Product Change Notice (PCN)

PCN Number: PCN-0450884R-01

Product(s) Affected: PJ1-023-SMT-TR

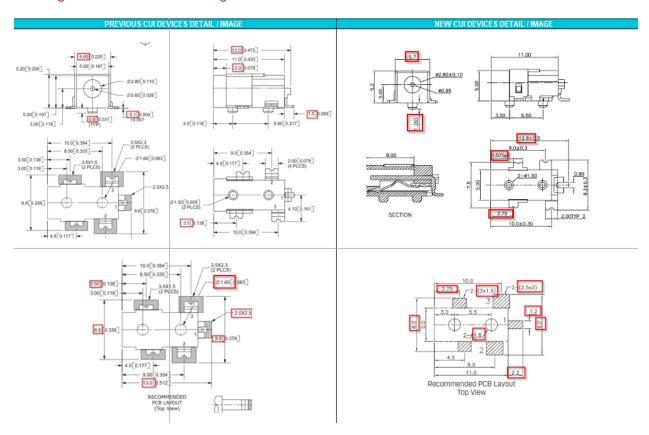
Description of Change: Minor Housing and footprint differences. Material Change on the housing and terminals. See image Below

NEW CUI DEVICES DETAIL / IMAGE		
DESCRIPTION	MATERIAL	PLATING/COLOR
center pin	brass	silver
terminal 1	brass	silver
terminal 2	SUS301 t=0.25	silver
terminal 3	brass t=0.40	silver
shield	brass t=0.40	silver
housing	PA9T (UL94V-0)	black
